This SI 142/90 contains information about modifications that have to be done on the D820-48. This set of modifications has been named Version 1.0 .

3. MODIFICATION INSTRUCTIONS

1.328.602-20 CR REMBUS + PROCESSOR

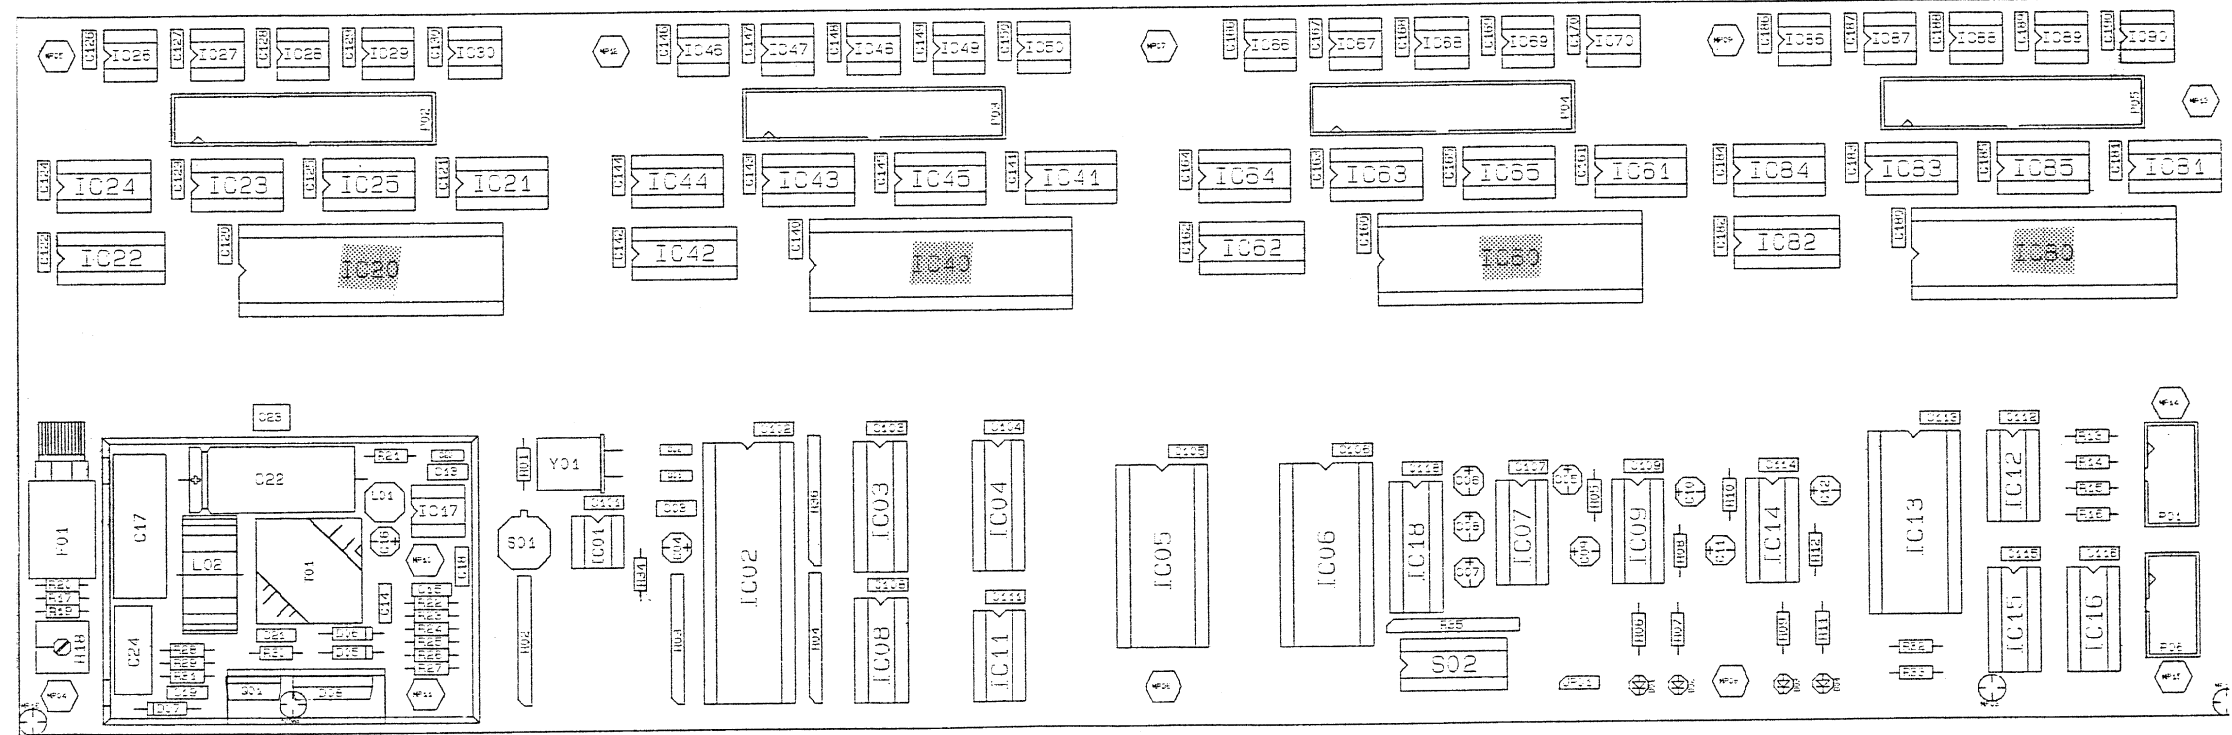
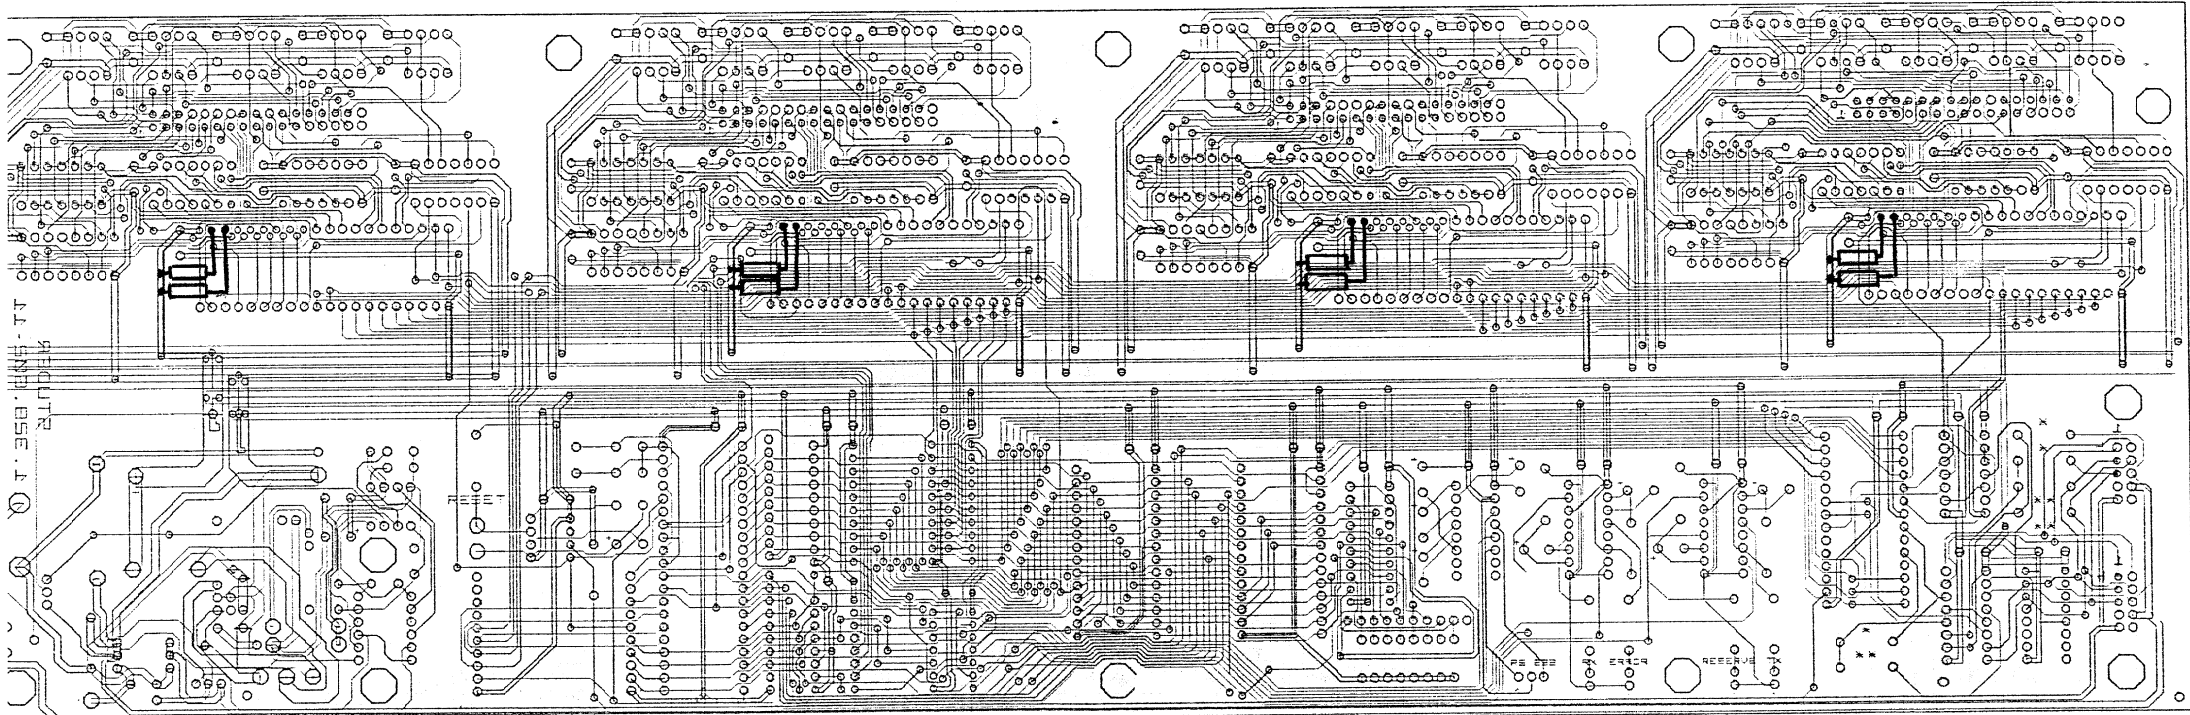
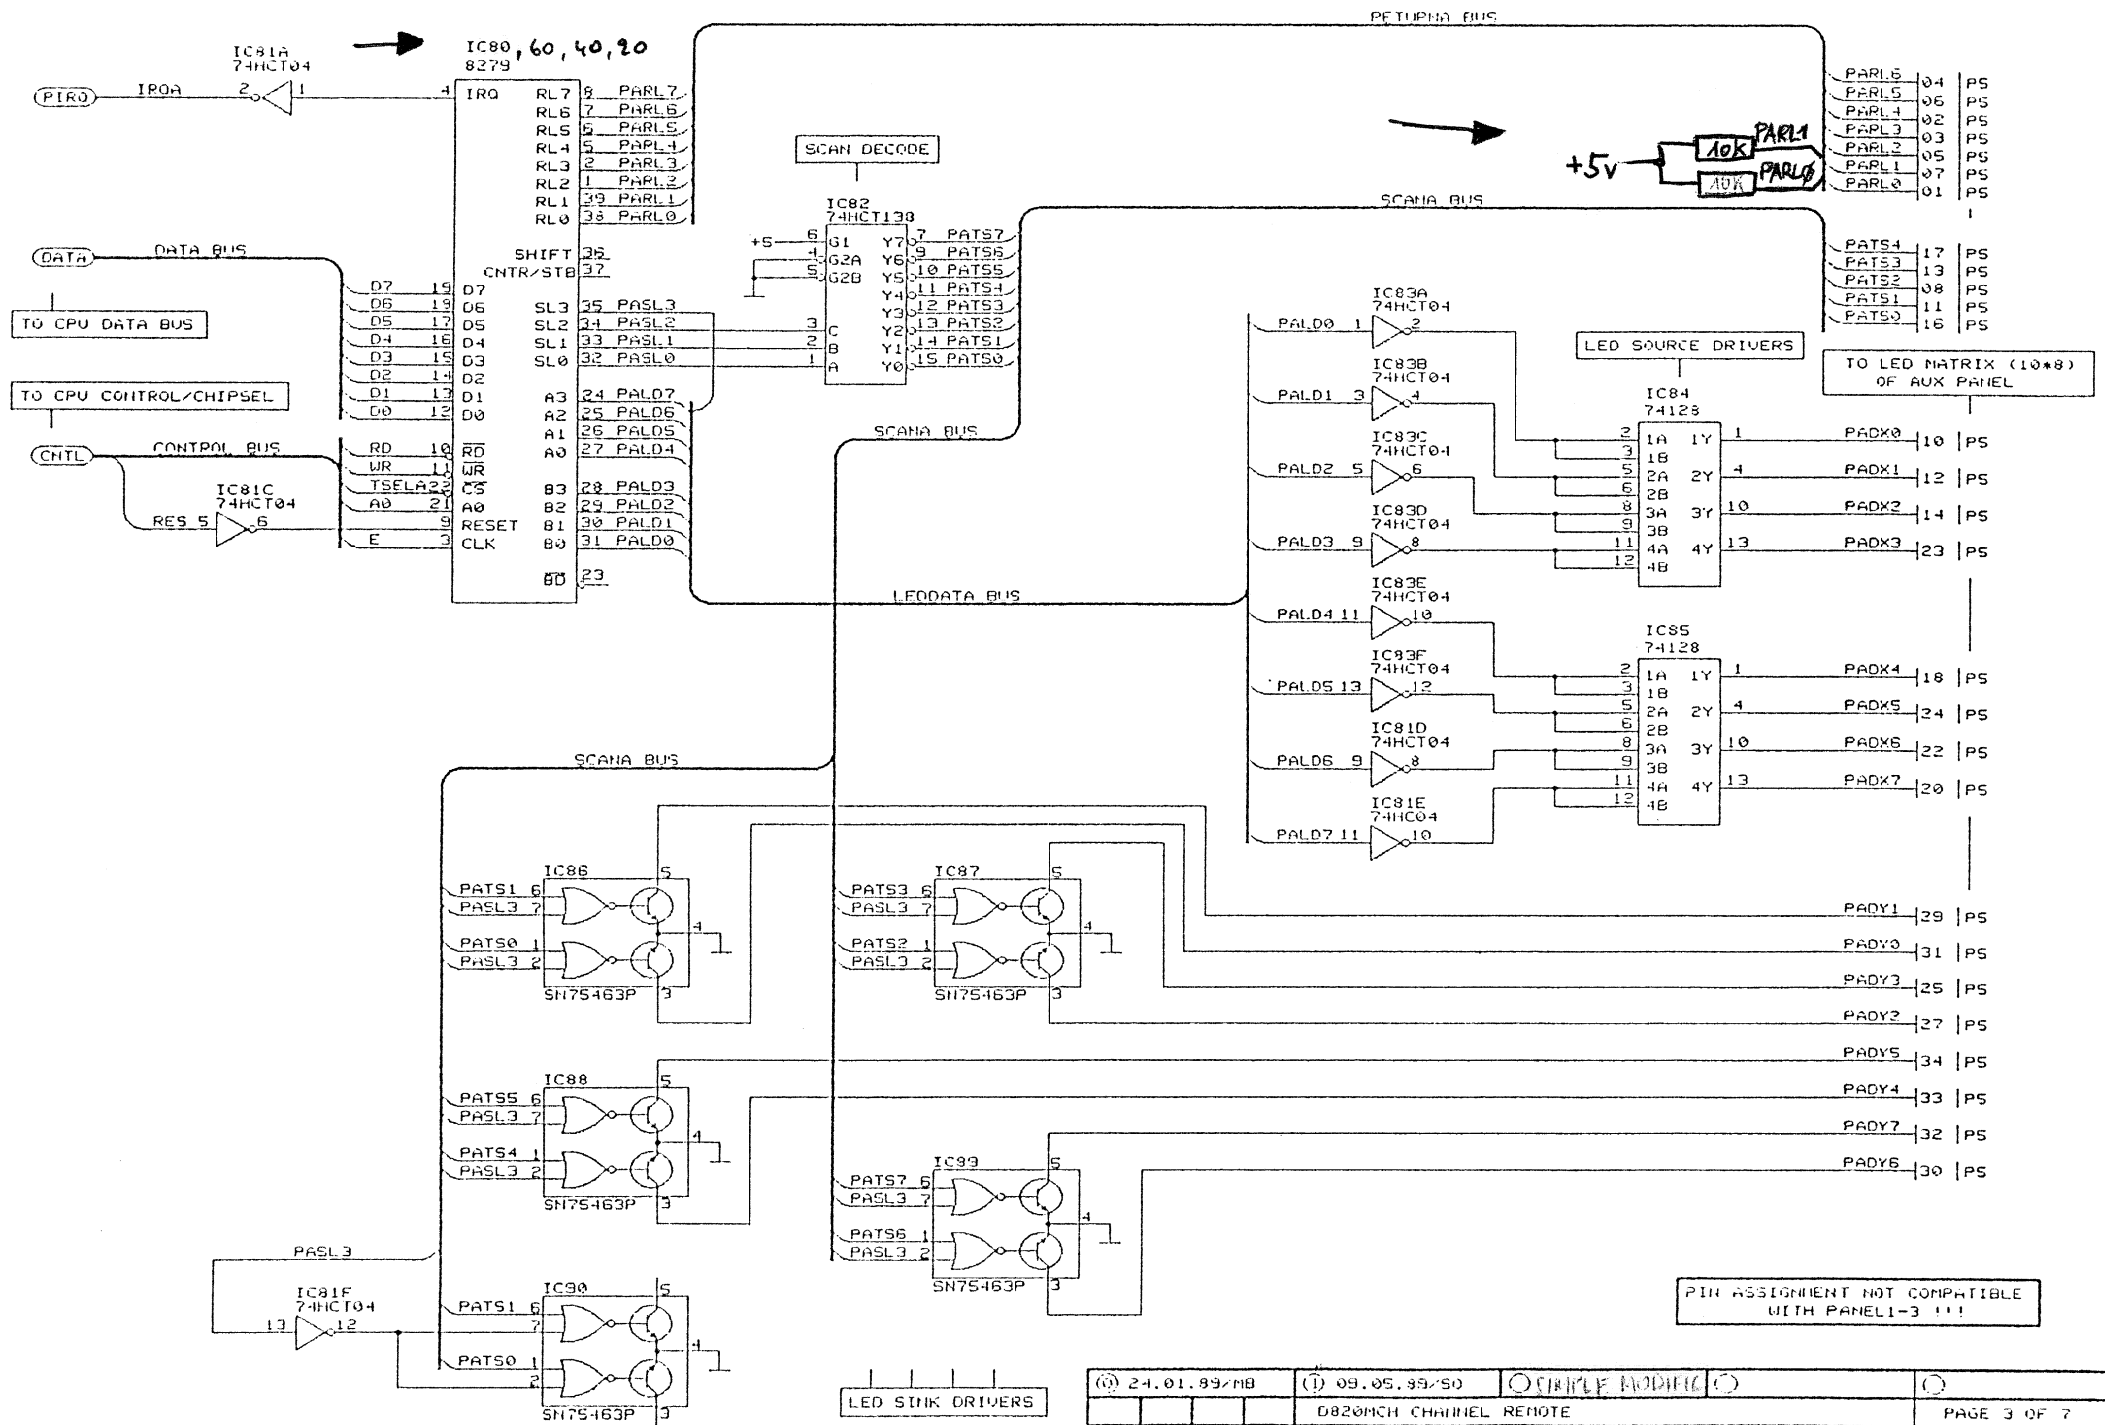
Solder two pull-up resistors each (10 k Ω , 57.11.3103) to the following IC's:

IC 20 , R 40/41	}	
IC 40 , R 42/43	}	from pins 38 & 39 to + 5V
IC 60 , R 44/45	}	
IC 80 , R 46/47	}

Connect pins 38 & 39 of ICs 20, 40, 60, 80 to 5V via a 10kΩ Pull-up resistor
(8279) (to be added)

→ Add resistors (8 × 10kΩ) on soldering side
